Access Compliance Report

Public Rights-of-Way

(Curb Ramps)

Intersection ID: 27680	Main Street: LANCASTER_HY	Cross Street: BALLANTYNE_COMMONS_PY	Location: SE
ADA ID: 112EF6AB3BCB	Ramp Type: Perp	Initial Pass/Fail: Fail	Overall Compliance: No
		Severity Score: 10

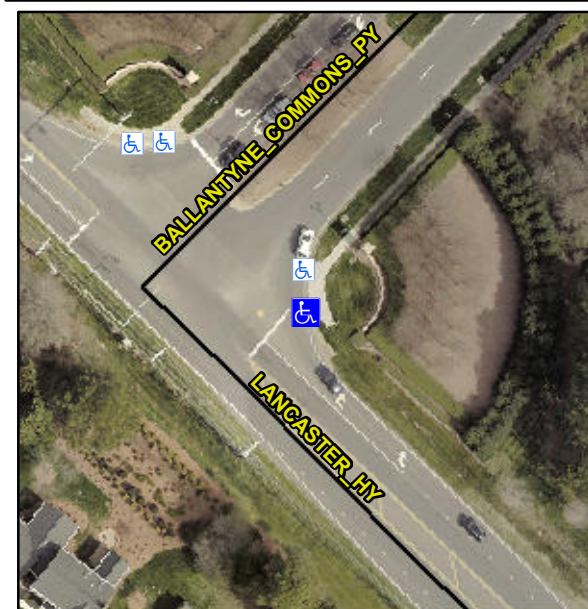
Not Found, R304.5.1, R304.5.3

Compliance	Description	Data	Compliance	Description	Data
N/A	Ramp Length (in)	48.0	Yes	Ramp Slope (%)	6.8
No	Ramp Width (in)	47.0	No	Ramp XSlope (%)	3.8
N/A	Flare Type LT	N/A	N/A	Flare Type RT	N/A
N/A	Flare Slope LT (%)	N/A	N/A	Flare Slope RT (%)	N/A
N/A	Flare Traversable LT?	N/A	N/A	Flare Traversable RT?	N/A
N/A	Landing Length (in)	N/A	N/A	DWS Provided?	N/A
N/A	Landing Width (in)	N/A	N/A	DWS Contrast?	N/A
N/A	Landing Slope (%)	N/A	N/A	DWS Length (in)	N/A
N/A	Landing X Slope (%)	N/A	N/A	DWS Full Width?	N/A
N/A	Landing Curb? (Y/N)	N/A	N/A	DWS Offset (in)	N/A
N/A	Shared Landing?	N/A			
N/A	Gutter Ponding?	N/A	N/A	Gutter Slope (%)	N/A
N/A	Gutter Lip Ht (in)	N/A	N/A	Gutter X Slope (%)	N/A
N/A	Painted X Walk1?	No	N/A	Painted X Walk2?	N/A
	X Walk 1 Direction	To SW		X Walk 2 Direction	N/A
N/A	X Walk 1 Width (in)	N/A	N/A	X Walk 2 Width (in)	N/A
	X Walk 1 Slope (%)	0.4		X Walk 2 Slope (%)	N/A
	X Walk 1 X Slope (%)	0.3		X Walk 2 X Slope (%)	N/A

Remove & Replace Entire Ramp.
